REVISED RESPONSE TO REQUEST FOR ADDITIONAL INFORMATION

APR1400 Design Certification

RAI No.: 235-8275
SRP Section: 12.03 – 12.04 – Radiation Protection Design Features
Application Section: 12.03 – 12.04
Date of RAI Issue: 10/07/2015

Question No. 12.03-46

Figure 10.4.8-1 Steam Generator Blowdown System Flow Diagram (Sheet 2 of 2)

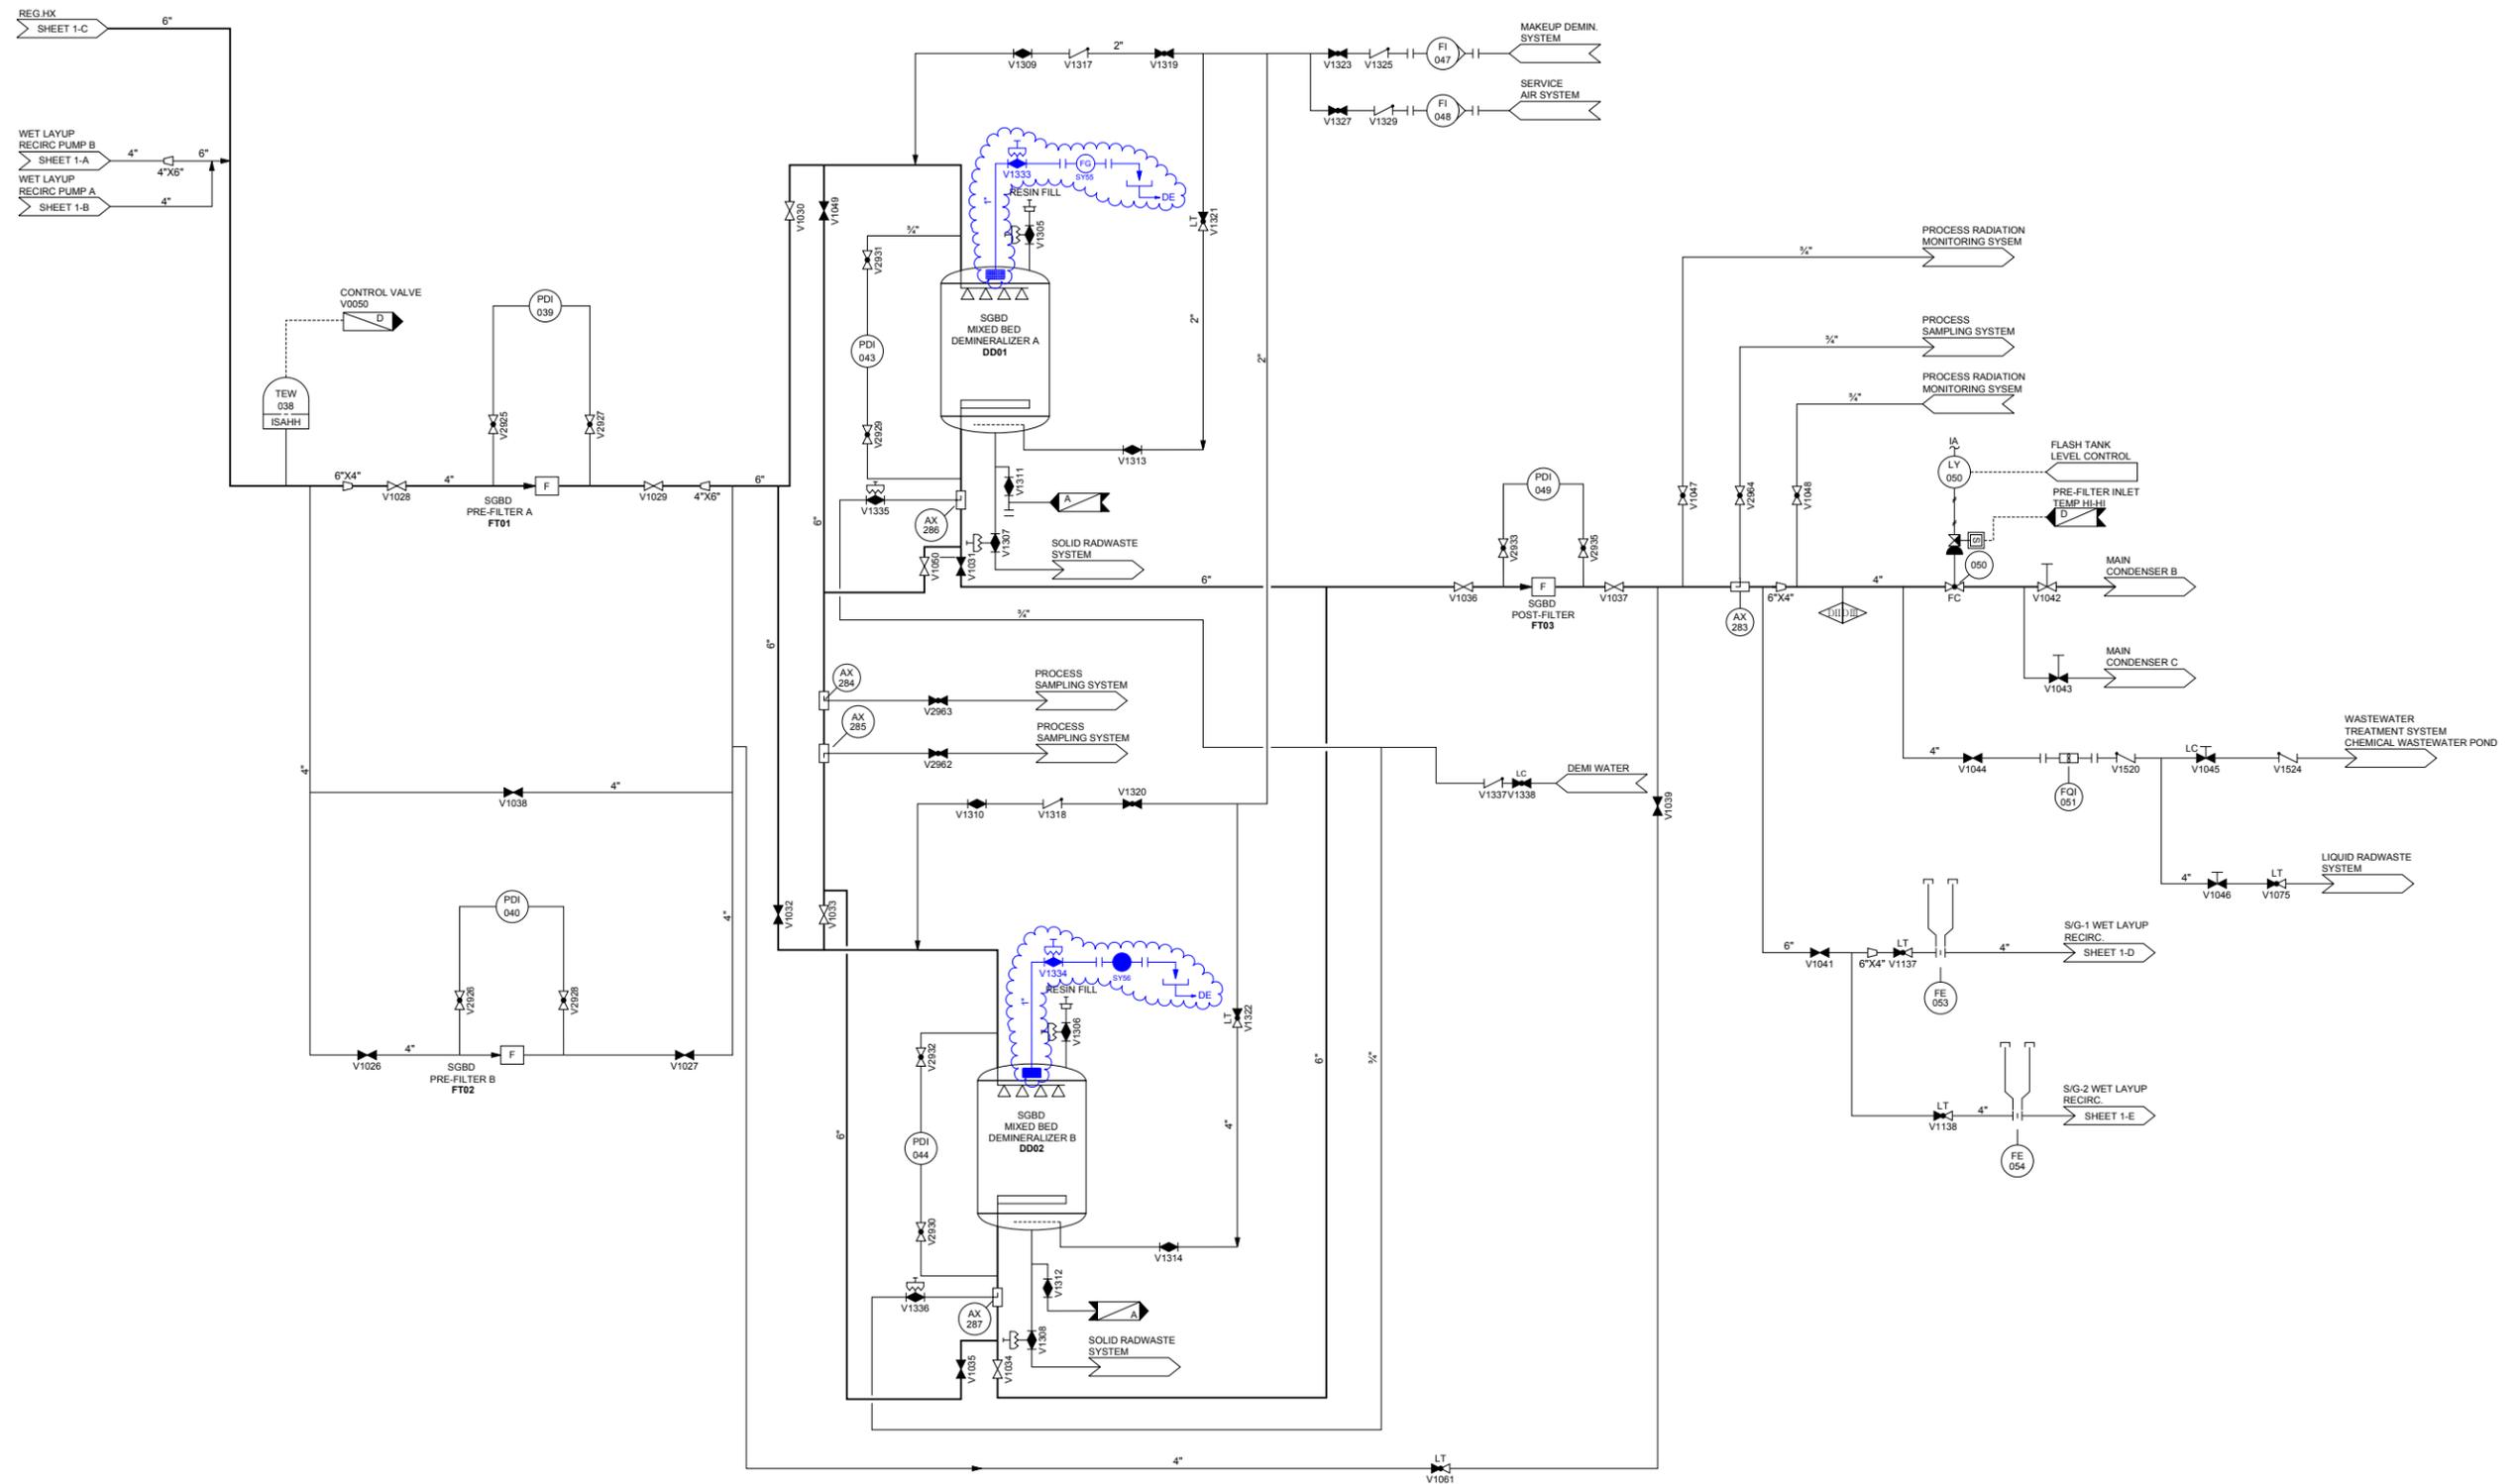
Neither the response nor the DCD system figures discuss or show where the demineralizers, other than the CVCS system demineralizers (such as LWMS and SGBD demineralizers), are vented to or show retention elements, similar to what is shown for the CVCS system demineralizers. This level of information is appropriate in the DCD in order to ensure that the RG 1.189 criteria of controlling flammable/explosive gases from ion exchange columns is met and for ALARA and minimizing contamination considerations. In addition, DCD Figure 9.3.4-1 shows that the CVCS demineralizers and other components in the CVCS system are vented to the room vent. It is unclear why it is appropriate to vent CVCS system components to the room ventilation system, instead of the gaseous radwaste system, when the CVCS system fluid could be expected to contain significant levels of gaseous radwaste.

For the SGBD demineralizers, a vent line is located from the top of each SGBD demineralizer which is routed to the proximity of the floor drain inside the SGBD demineralizer room. During venting, the SGBD demineralizers are vented to the room atmosphere for collection by the controlled building radioactive HVAC system. The potentially contaminated vented air is treated within the HVAC system prior to release to the environment. DCD Tier 2 Figure 10.4.8-1 (Sheet

2 of 2) showing the SGBDS flow diagram will be revised to add the omitted vent design of the SGBD demineralizers as indicated in the Attachment 5.
